Moose Range Meadows, 2024 Replat Preliminary Plat

ITEM #2 - PRELIMINARY PLAT MOOSE RANGE MEADOWS 2024 REPLAT

KPB File No.	2024-059
Plat Committee Meeting:	June 24, 2024
Applicant / Owner:	Joseph & Elizabeth Bahr of Soldotna Alaska
Surveyor:	Jerry Johnson of Johnson Surveying
General Location:	Funny River Rd in the Kenai National Wildlife Refuge, Funny River APC

STAFF REPORT

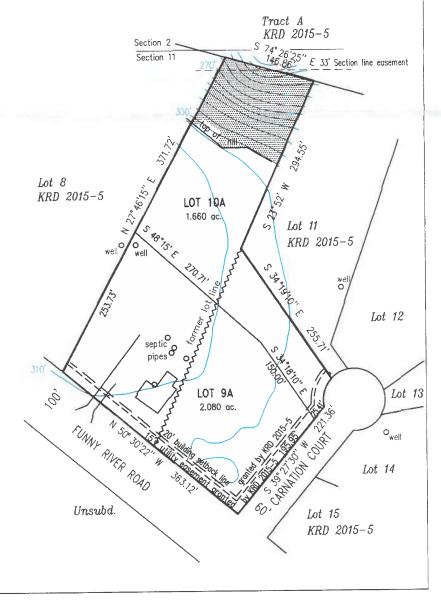
There appears to be a structure on proposed Lot 9A along with a septic system and well according to the plat drawing. The new lot configuration looks to be adjusting the lines to fix the structure from being too close to the previous joint lot line of lot 9 & 10.

There is a steep area indicated in the north portion of the plat located on Lot 10A. The contours can be removed for the final and the shaded portion of the steep area can be left on the final drawing.

The plat name needs to be changed or revised as the extension "2024 Replat" is too similar to a previously approved nearby subdivision having the extension "2024 Addition".

There is a 10-foot utility easement along the northeastern side of Funny River Rd, as recorded in Book 559, Page 341 KRD, that needs to be depicted on the drawing with the addition of a plat note.

The well, septic pipes, and house structure can be removed from the final drawing. Overall distance on westerly line is off by 200 feet, should be 571.72'. Curve data needs to be added along Carnation Ct.

- Need new plat name too similar to previously approved plat. Maybe change "2024 Replat" to "Bahr Replat".
- Add KPB No 2024-059 to Title Block.
- Change the owners' names in Title Block to Joseph Steven & Elisabeth Ann Bahr to match the Certificate to Plat.
- Add a comma in the legal description after T4N.
- C. The location, width, and name of existing or platted streets and public ways, railroad rights-of-way, and other important features such as section lines or political subdivisions or municipal corporation boundaries abutting the subdivision;

Show the section line easement on the north side on the section line.

There is an extra "Dr" along Keystone Dr. in the vicinity map.

Possible driveway encroachment from Lot 11 onto proposed Lot 10A, surveyor should note when doing field survey if there is actually an issue.
